PG&E Letter DCL-15-142

Response to NRC Letter dated November 5, 2015, "Request for Additional Information Related to the Environmental Review of the Diablo Canyon Power Plant, Units 1 and 2, License Renewal Application (CAC Nos. MF4019 and MF4020)"

Pacific Gas and Electric Company's Response to Nuclear Regulatory Commission's "Request for Additional Information Related to the Environmental Review of the Diablo Canyon Power Plant, Units 1 and 2, License Renewal Application," dated November 5, 2015

Figure AIR-7-16

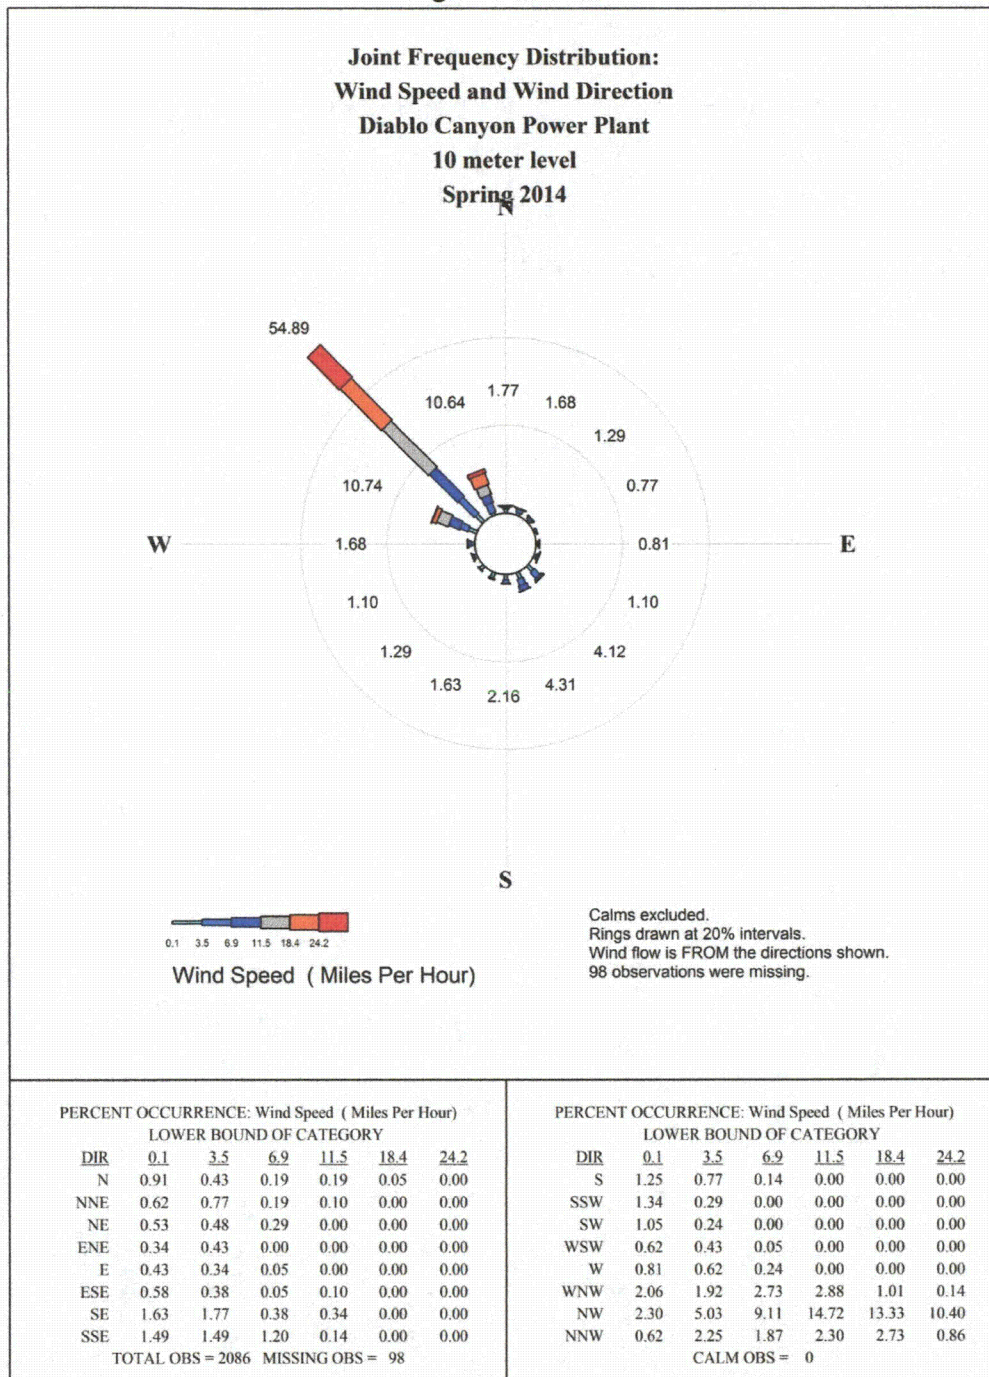
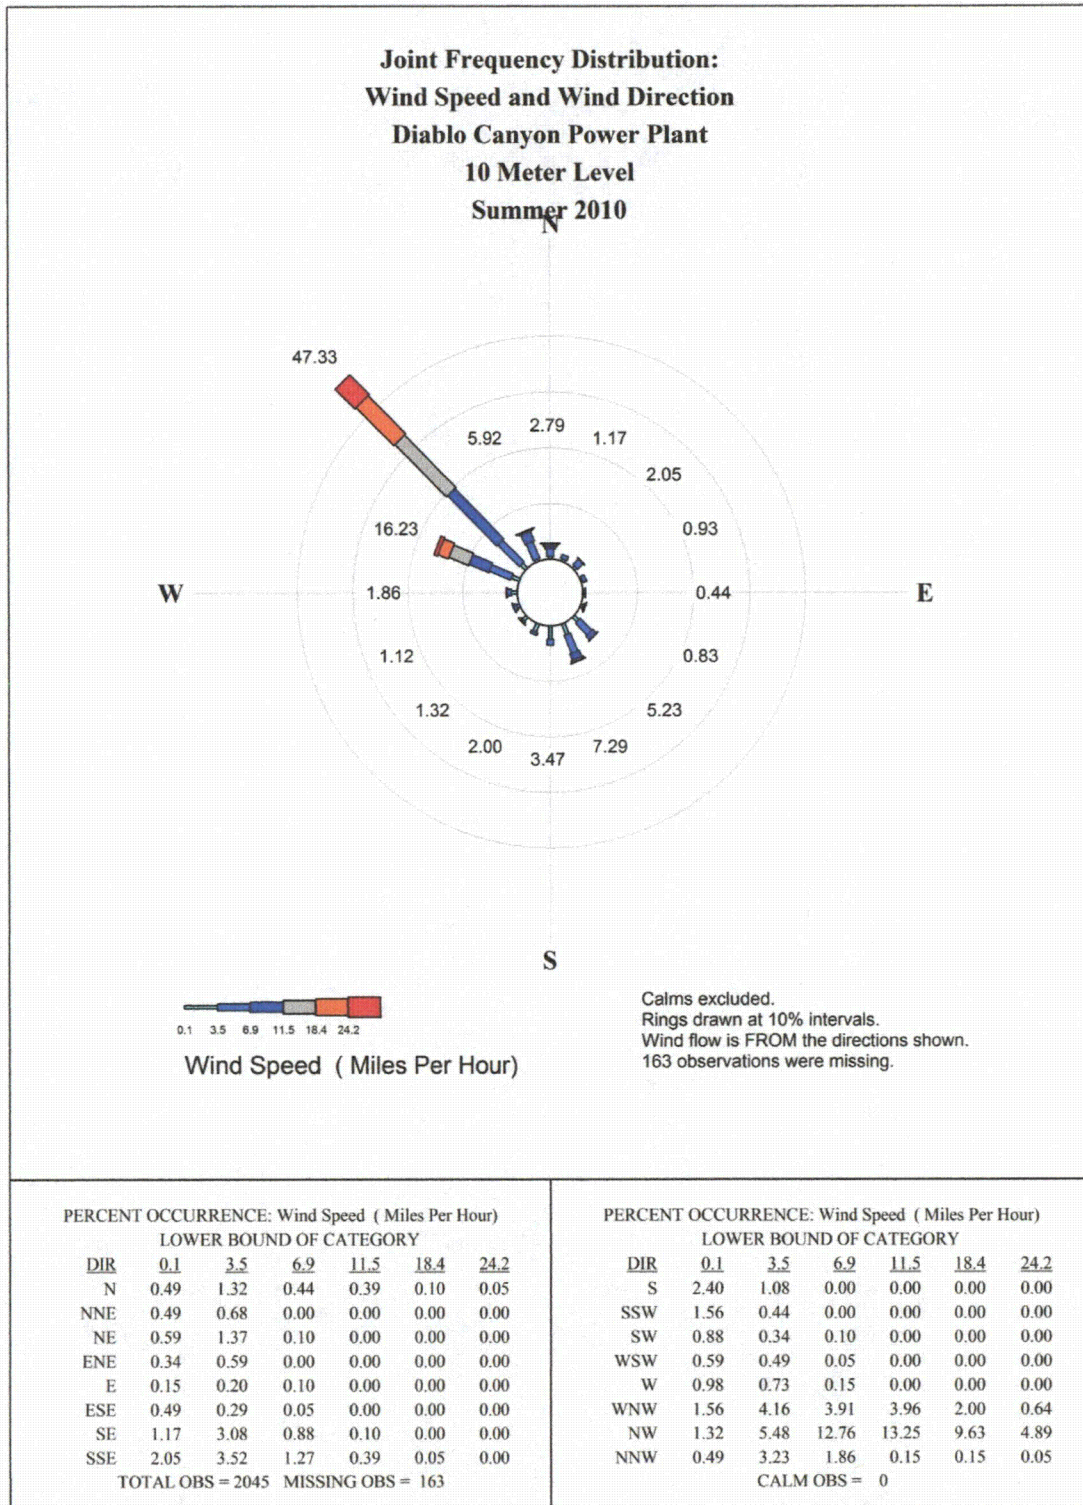
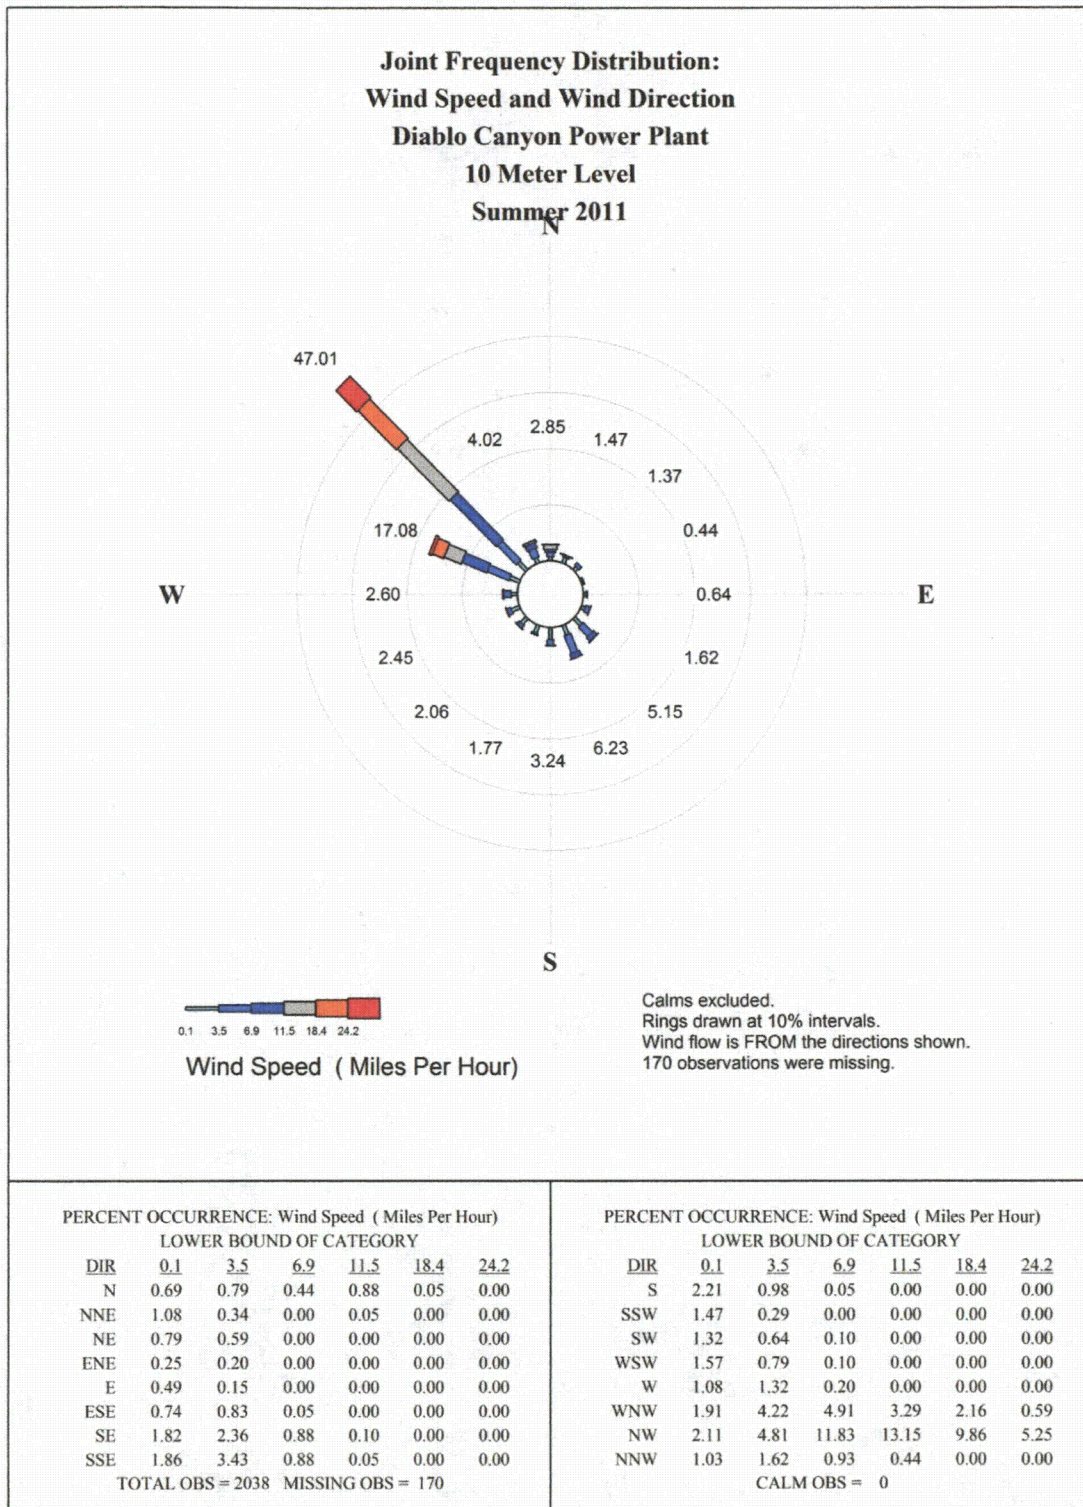
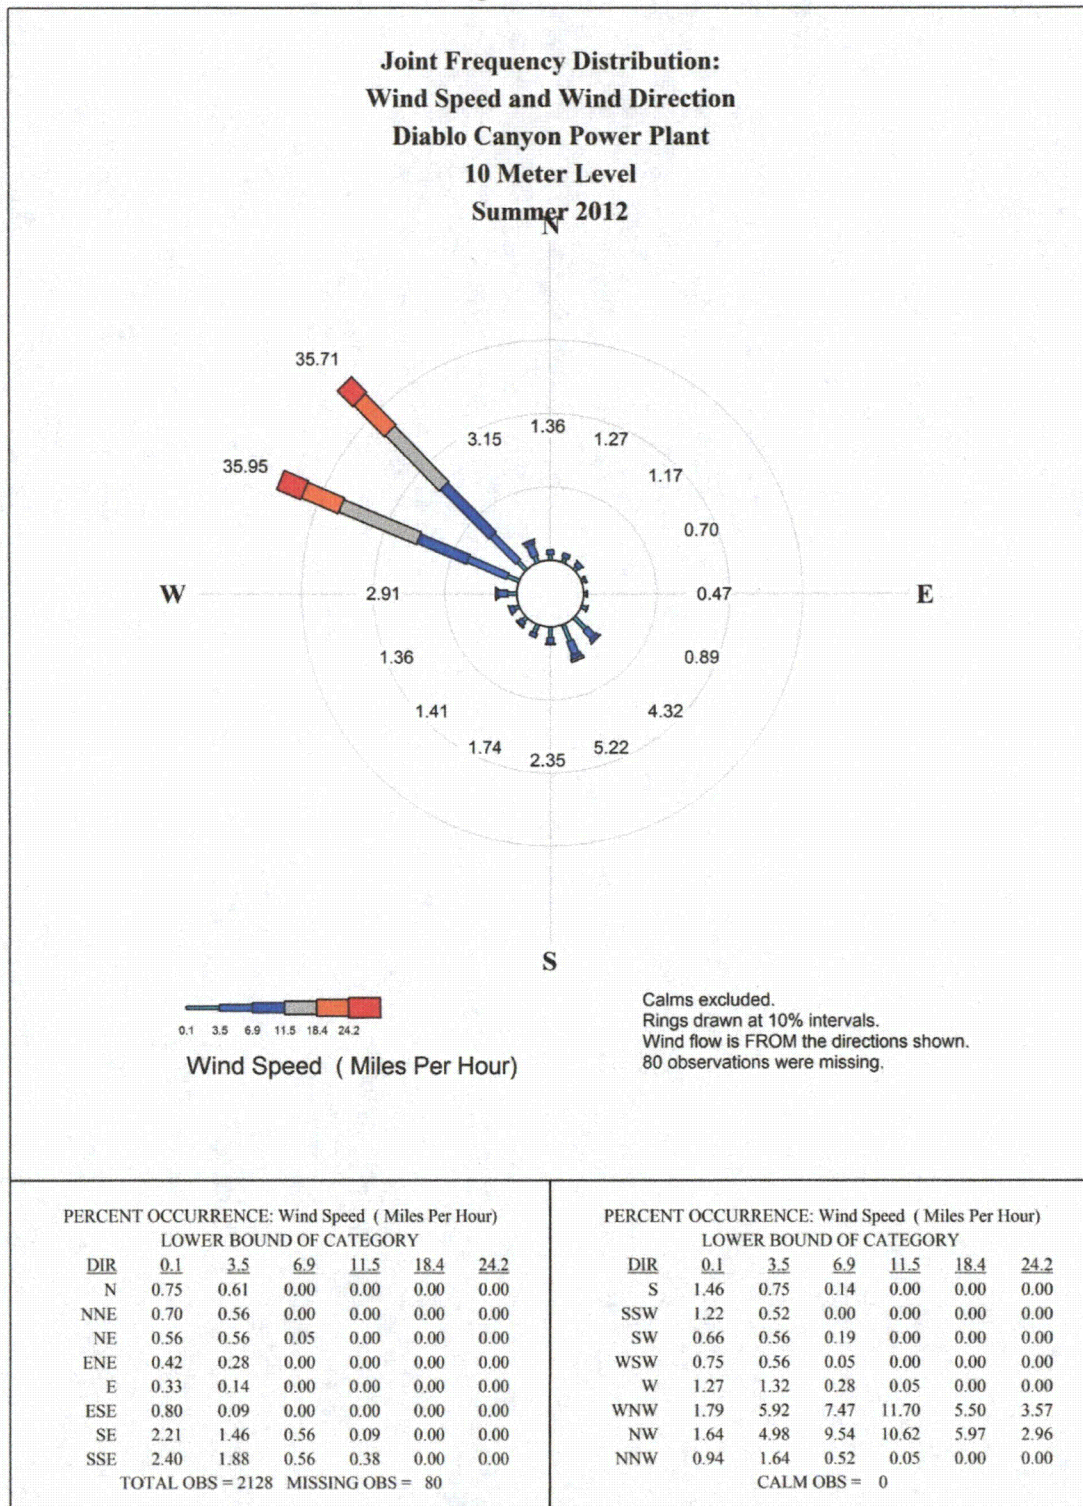
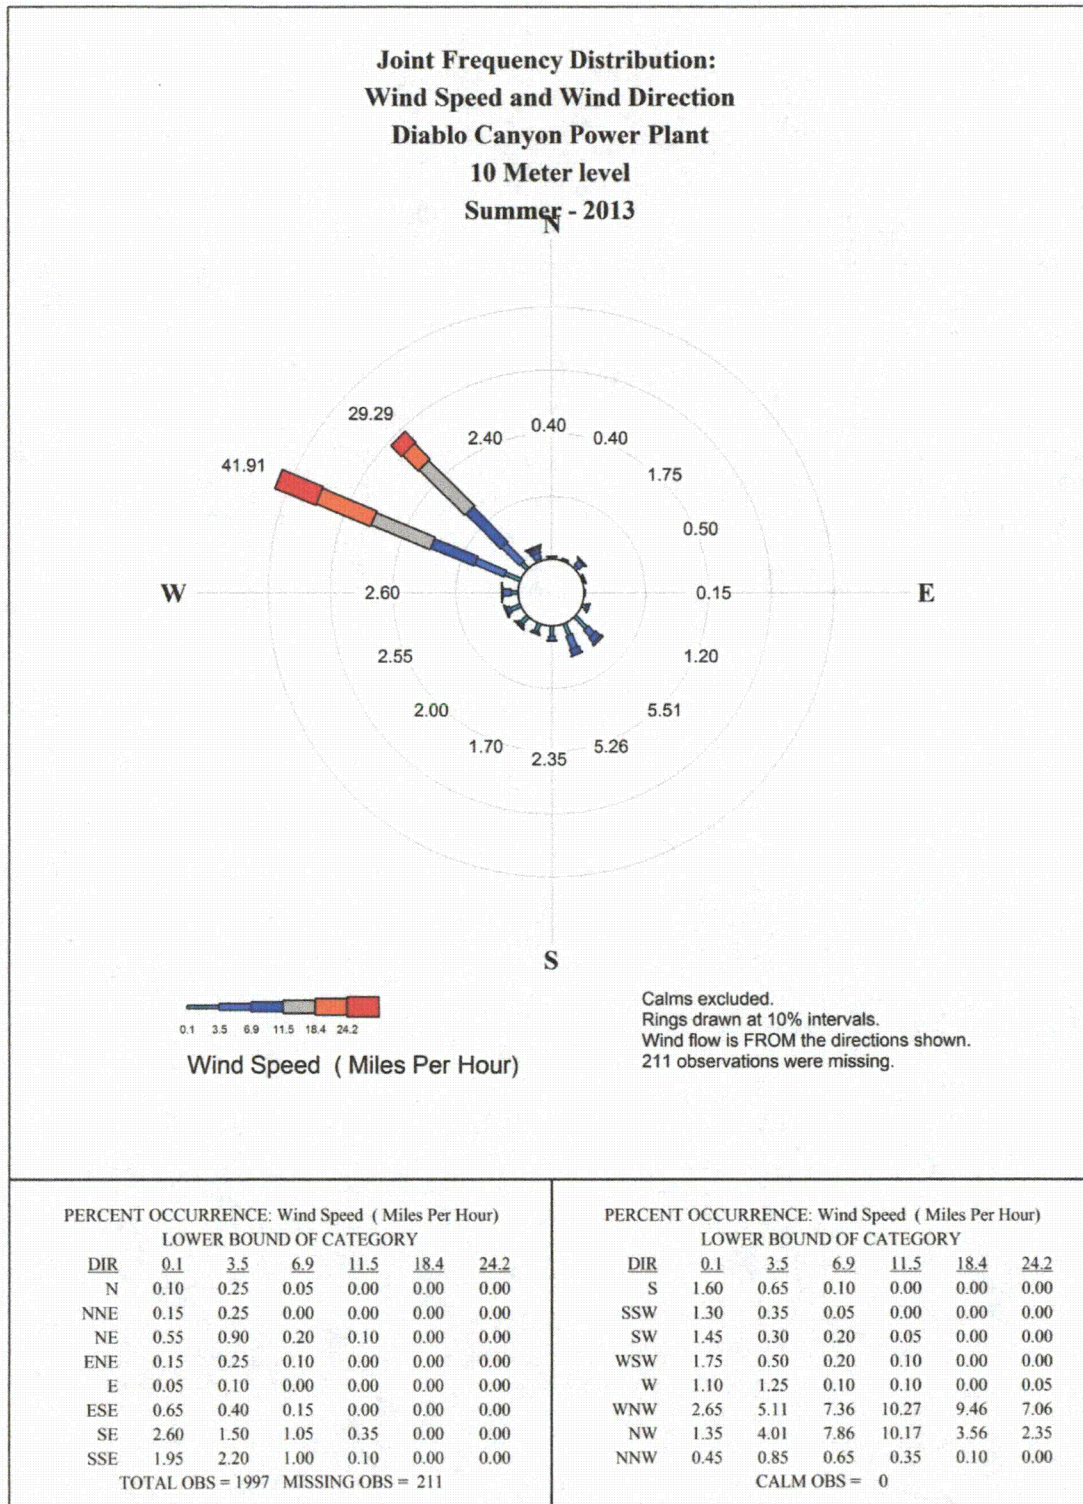
Provide seasonal and annual summary wind statistics in the form of wind direction and speed frequency distribution tables and wind roses from data recorded at DCP's meteorological facility. Discuss predominant wind direction and speed by season and annual average. The meteorological data should include the most recent 5 years for which the data are available.

The annual and seasonal wind direction frequency of occurrence for the DCP primary tower 10-m level for the period 2010 to 2014 are presented in Attachment 2, Tables AIR-7-1 through AIR-7-5. Annual and seasonal wind roses for DCP for the 2010 to 2014 periods are presented in Attachment 1 Figures AIR-7-1 through AIR-7-25. The wind rose presents the joint frequency of wind speed and wind direction recorded at the 10-m level at the plant. The wind direction is presented in 16 principal directions (north, north-northeast, northeast, north northwest) with each direction category encompassing a 22.5-degree sector centered on that direction. Six wind speed categories are used with the lower bounds at 0.1, 3.5, 6.9, 11.5, 18.4, and 24.2 miles per hour (mph). The length of each color band represents the frequency of a specific wind speed range. For example, northwesterly winds greater than 24.2 mph occurred 4.1 percent of the time for the period 2010 to 2014. Furthermore, below each wind rose diagram, is the same data displayed in table form for a more detailed breakdown of the seasonal wind direction and speed frequency distribution.
